Re: Change Order #7 Bullitt Lick Middle School
Roof Asbestos Testing

Change Order

Bullitt Lick Middle School
555 W Blue Lick Road
Shepherdsville, KY 40165

CHANGE ORDER REQUEST NO. 007

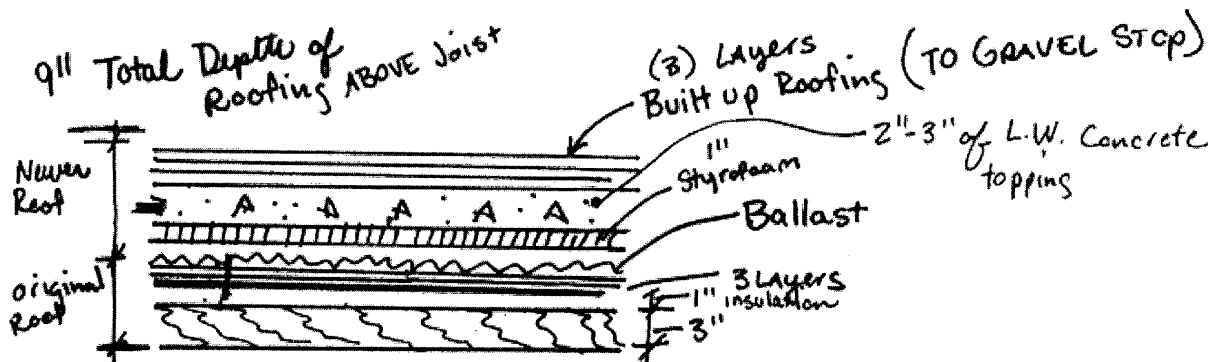
EH Construction alerted Studio Kremer Architects and BCPS district staff to an unforeseen condition at the roof on April 27, 2018. The roof composition found at BLMS is different than what was assumed based on original documents. The roof composition found lead the A/E and Construction team to believe the original roof was left in place and a new roof was built over it that included a 2" – 3" layer of light weight concrete. The roof layers are noted and illustrated below:

Due to the layer of concrete, Studio Kremer Architects sent this information to Slesser Engineering, the structural engineer, to review the total weight of the roof assembly and see if the structure is overstressed due to the added weight of the light weight concrete. Slesser Engineering found the structure is 20% overstressed with just the dead load (weight) considered and 60% overstressed with both dead load (weight) and live load (snow, people, wind, etc.) considered.

Based on this unforeseen condition EH Construction is requesting a change order to the contract in the amount of **\$2,500**, not charging their typical overhead and profit on this scope of work in an effort to proceed with the work without delay. Studio Kremer Architects will also not charge their contract percentage fee for this work since it involves testing rather than construction.

We have reviewed the additional cost associated with testing of the roof and agree with the lump sum fee required to complete this work as presented by Abatement Solution Technologies. Based upon the information provided we recommend that the Bullitt County Board of Education approve the Change Order as presented.

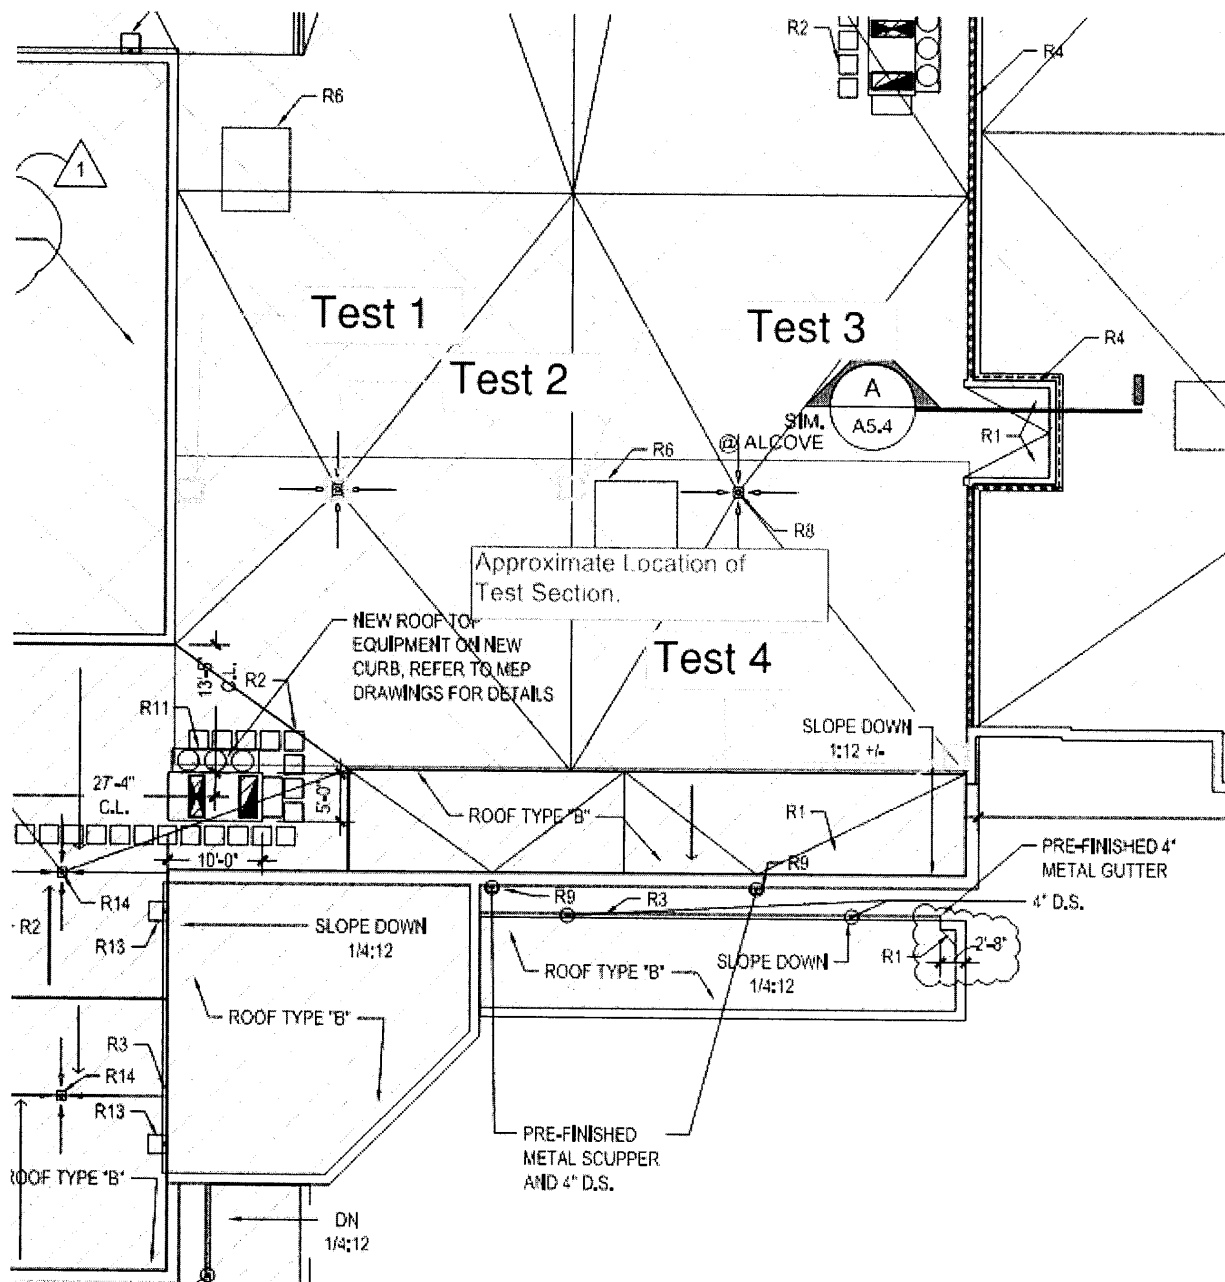
Please see the attached sketch with test areas indicated – what we'd like to check is the total weight of the existing roof assembly to verify it's deadload.

We request (4) test cuts, each 1 square foot in size that encompasses the entire roof assembly down to the deck + a 1 square foot piece of the existing tectum roof deck. (Don't cut into the tectum deck at each test area). Once those (4) test areas are cut, bag them and weight them with the piece of tectum to give us the total weight of each test. What we're hoping to see is whether the light weight concrete changes in thickness, thus reducing the overall weight on the structure. We'd like to have a representative from GEM on site to document the proceedings – Bret would you agree to having GEM perform this additional oversight for the District? If so, I can contact Rob Peck to discuss this work.
